**TECHNICAL BULLETIN**  
**Bell Helicopter** **TEXTRON**

No. 407-04-59

**MODEL AFFECTED:** 407

**SUBJECT:** MAIN ROTOR FLIGHT CONTROLS ANTI-FRETTING WASHERS 140-005-19-16-4 AND 140-055-1, INSTALLATION OF.

Figure 1. Washer installation on Support Assembly

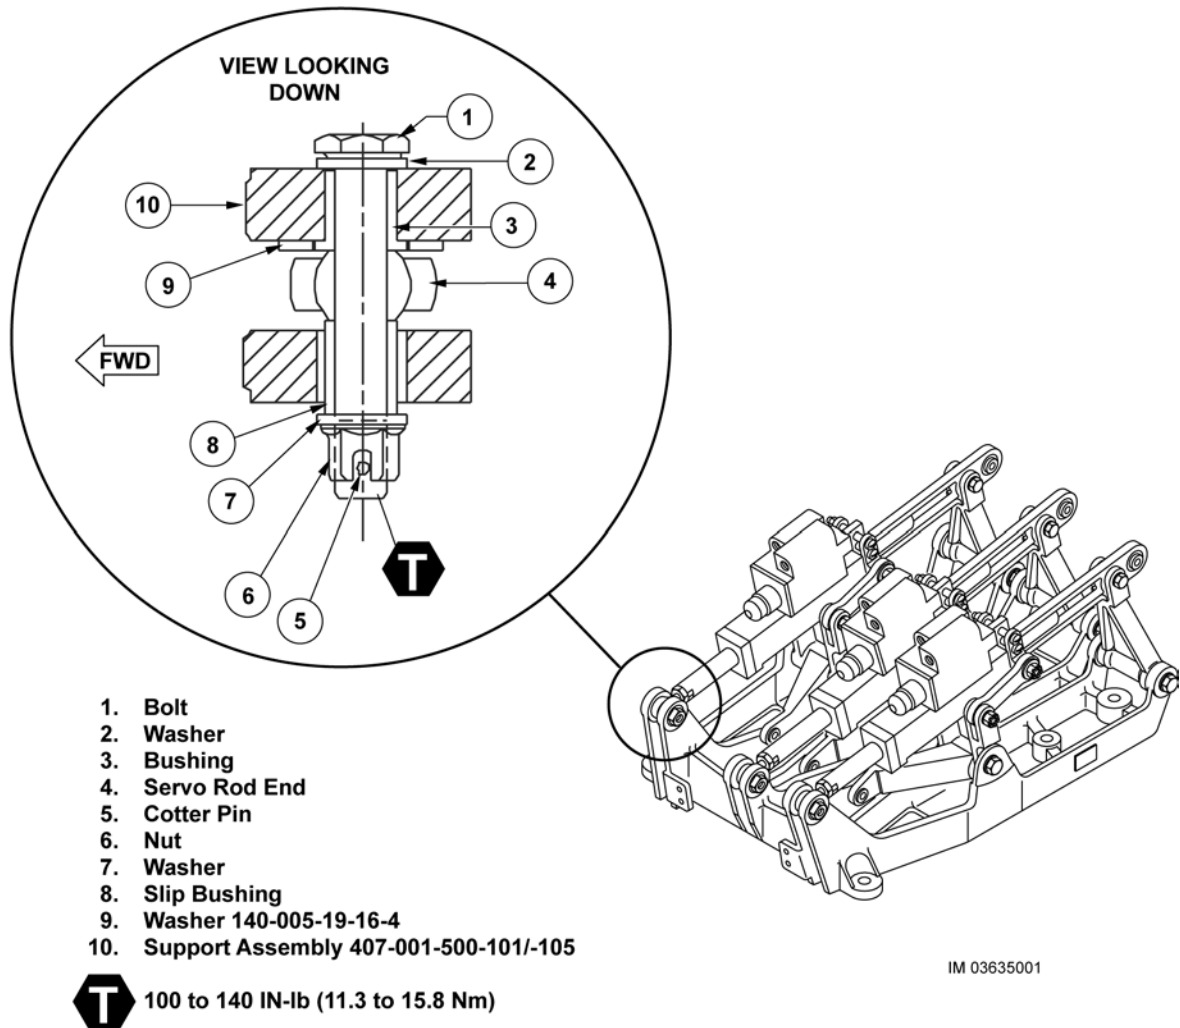
PART I of this Technical Bulletin provides installation instructions of washer 140-005-19-16-4 at three locations to prevent chafing damage on the hydraulic servo support assembly.

1. Disconnect the hydraulic servo actuators from the support assembly at the forward attachment point. Make sure the servo actuators are properly supported and protected to prevent damage. Refer to Figure 1.
2. Clean and inspect support assembly for damage in the actuators forward attachment point area.
3. Install one rubber washer (9, Figure 1) with no adhesive at each lug of the support assembly on the fixed bushing side.
4. Install hydraulic servo actuators to support assembly at the forward attachment point. Refer to BHT-407-MM-4, chapter 29.
5. Make an entry in the helicopter records to show that PART I of this Technical Bulletin has been completed.

**Figure 2. Washer replacement on Bellcrank Assembly**

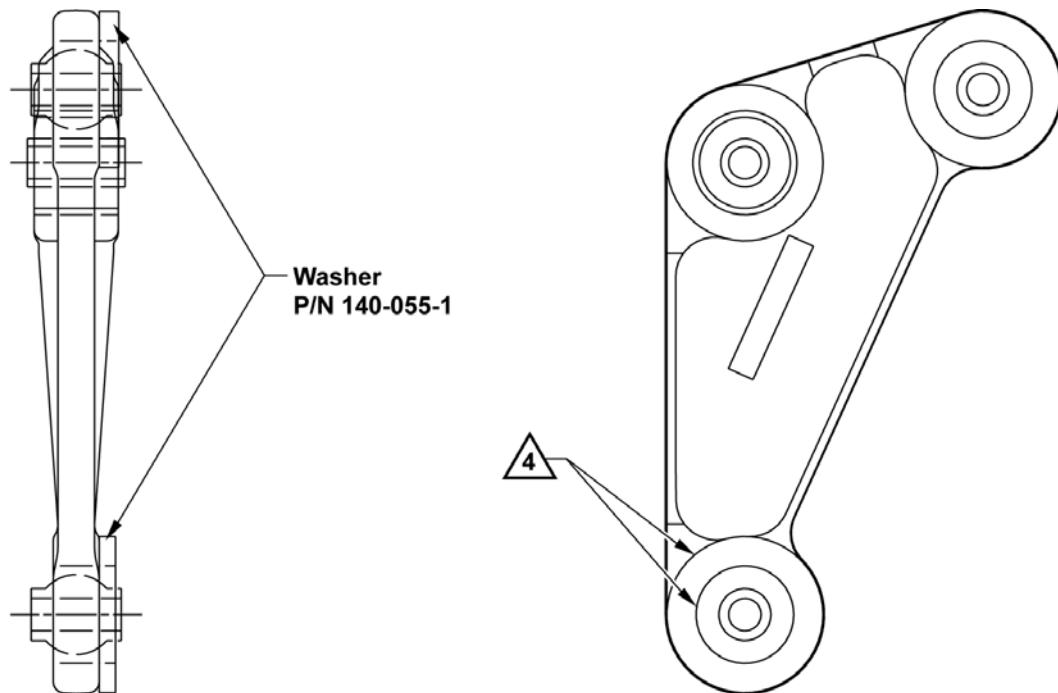
PART II of this Technical Bulletin provides instructions to replace the existing stainless steel and rubber washers with a nylon washer 140-055-1 to prevent chafing damage on main rotor control tubes clevis.

1. Disconnect main rotor control tubes from bellcrank. Protect disconnected control tubes from damage. Refer to BHT-407-MM-4, chapter 67.
2. Remove bellcrank from the helicopter.
3. Remove the stainless steel washers 140-009D60S96 and the rubber washers 140-005-30-24-8 from bellcrank using a sharp plastic scraper. Refer to figure 2.
4. Inspect bellcrank for damage.

7. Apply adhesive (C-301) to the prepared surface of washer 140-055-1. Bond washer to bellcrank. Apply between 5 and 20 psi pressure (34.5 and 138 KPa). Cure for two days at room temperature or 2 hours at 160°F (71°C). Refer to figure 2.

1. Washers P/N 140-009D60S96 and P/N 140-005-30-24-8 replaced with one washer P/N 140-055-1 at two locations.
2. Bond washer P/N 140-055-1 to bellcrank assembly with adhesive (C-301).
3. Do not allow adhesive and sealant to contact bearing.

- 4.** Apply a bead of sealant (C-251) around the inside and outside diameters of the washer 140-055-1 at mating surface with bellcrank.
